ADDENDUM NUMBER: ONE (1)

FOR: UAF Jean Tyson CDC HVAC Upgrades
University of Arkansas
Fayetteville, Arkansas
Pettit & Pettit Project #25-120

DATE: August 26, 2026

1 ELECTRICAL ROOM NEW WORK PLAN
SCALE: 1/4" = 1'-0"

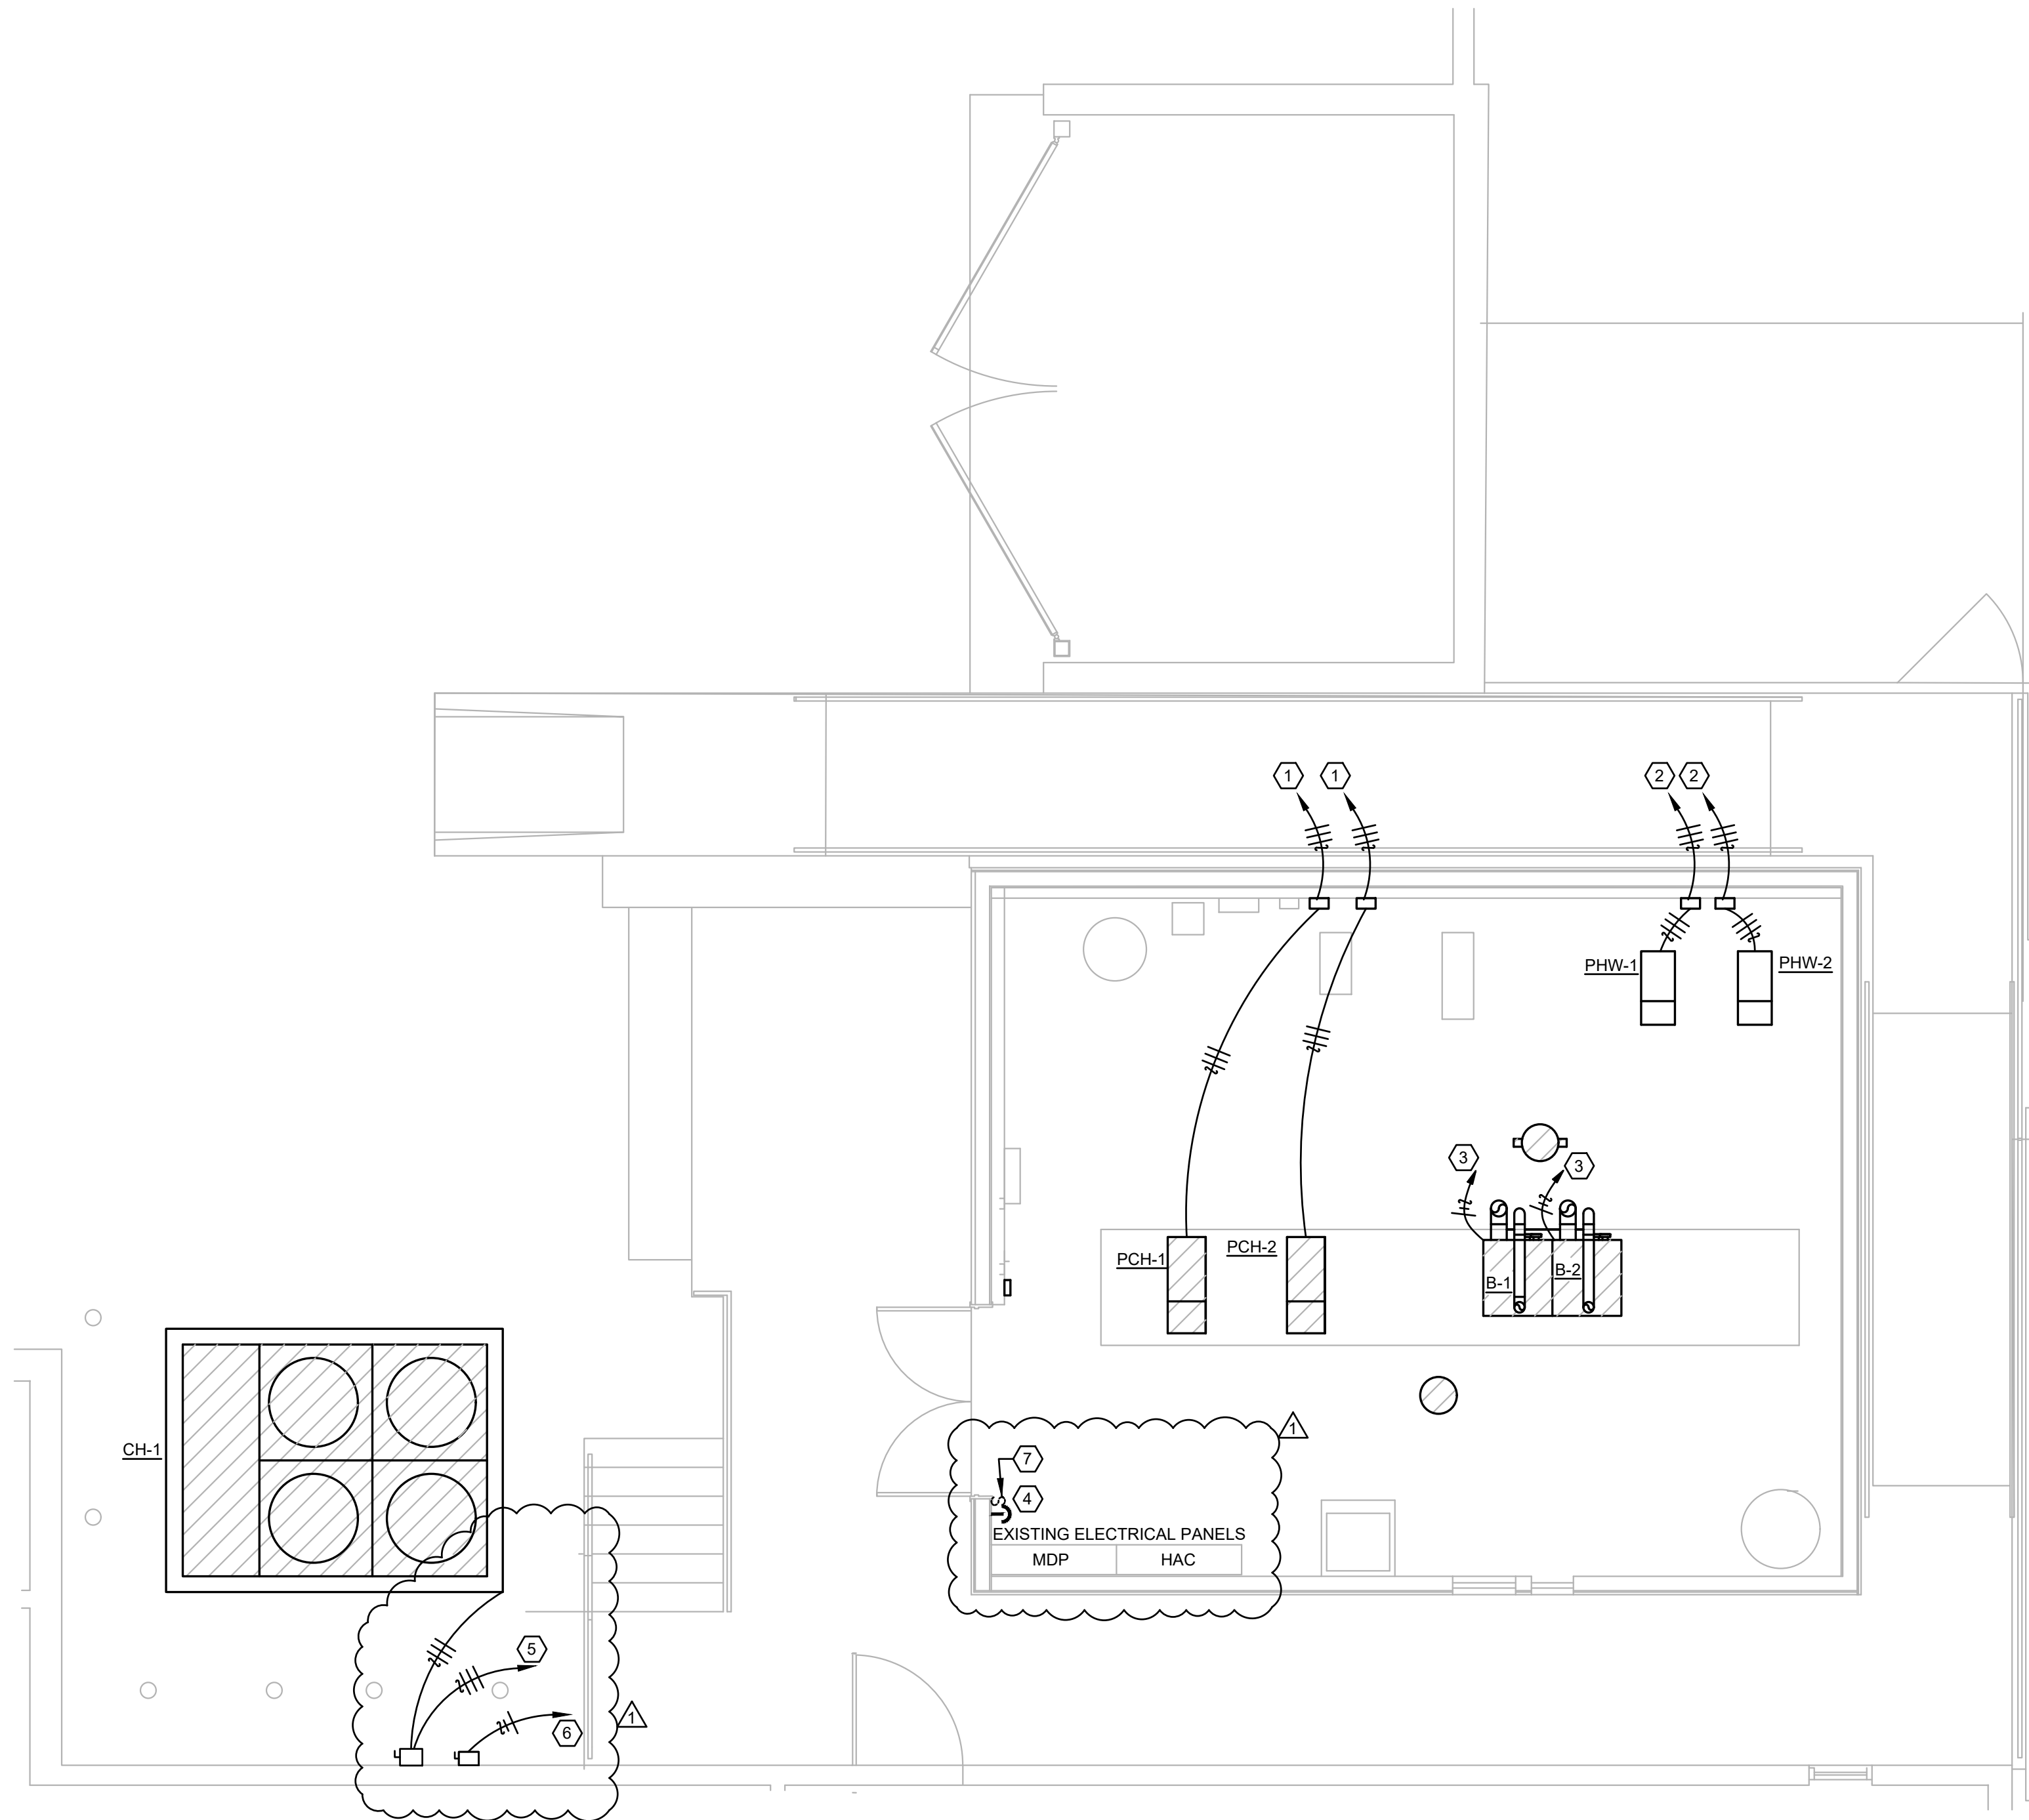
- A9.** REFER TO SHEET E1.0 – ADDED NOTE ABOUT RELOCATION OF THE EXISTING LIGHT SWITCH.
- A10.** REFER TO SHEET E1.1 – ADDED NOTE ABOUT RELOCATION OF THE EXISTING LIGHT SWITCH AND RELOCATED CHILLER AND HEAT TRACE DISCONNECTS.
- A11.** REFER TO SHEET E1.2 – ADDED NEW SHEET.

- 7 RELOCATE EXISTING LIGHT SWITCH.
